Your ref: SSD-65146459
Our ref: DOC24/971300-18

Thank you for your email regarding the updated survey methods for the Marulan Quarry Biodiversity Development Assessment Report (BDAR). Conservation Programs, Heritage and Regulation (CPHR) have reviewed the supplied report detailing the updated survey methods. We note that the following issues have been adequately addressed:

Attachment A

Koala survey information and known records within the subject land

Figure
1

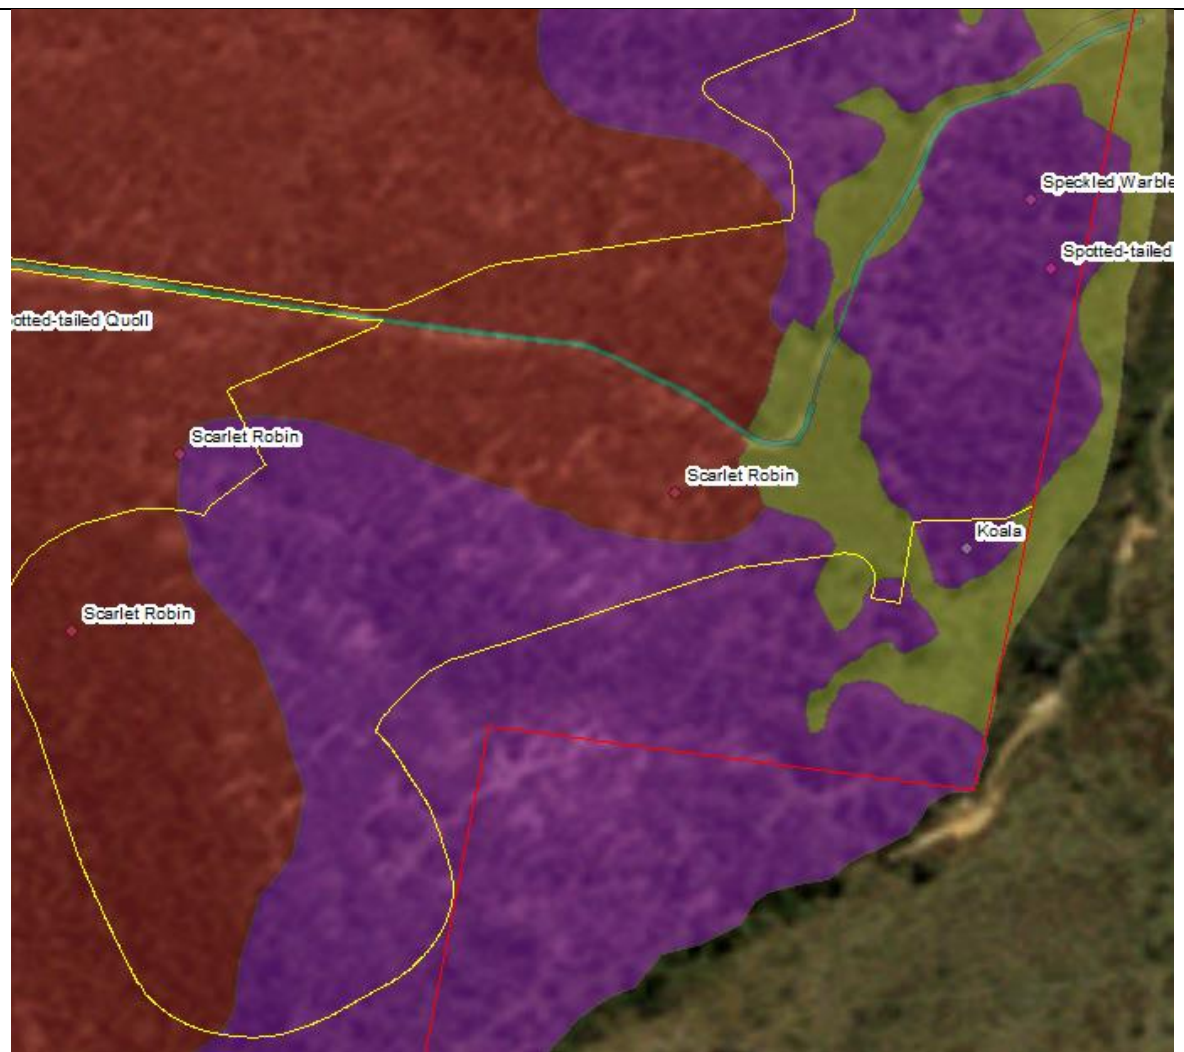
C	Known koala records within the subject land and surrounding areas From Marulan Quarry BDAR section 5.8 <i>'The closest record occurs adjacent to the proposal site in woodland next to Narambulla Creek recorded as part of a wildlife community survey'</i> <i>'The habitat associated with the wildlife community survey recordings is more fertile, well-watered and productive landscape positions with taller, more productive open forest and woodland containing higher cover of primary Koala food trees such as Blakely's Red Gum (Eucalyptus blakelyi), Yellow Box (E. melliodora) and Ribbon gum (E. viminalis).'</i> The koala record referenced in the report and shown in figure 1 is said to be in higher quality koala habitat however, the koala record is in a patch of vegetation that has the majority of its area within the proposal site. This patch is also listed as being the same vegetation zone and condition as sections of PCT 731 that will be impacted by the development as shown in figure 2. With approximately 20 meters of poor quality PCT 731 (as mapped by GHD) separating the vegetation patches there are no barriers stopping koala movement between these areas. It is unclear why the justification of it being higher quality koala habitat is used. BAM operational manual stage 1, section 4.4.4 states <i>'If there are existing records of a species on the subject land, and the current survey does not detect the species (or the population has changed), then evidence to justify the change should be provided in the BAR.'</i> The justification provided in the BDAR does not adequately address this and does not provide sufficient evidence. The justification in the BDAR to say koalas have a moderate likelihood of occurrence is not adequate considering the known record in the subject land and the surrounding areas that have high connectivity.
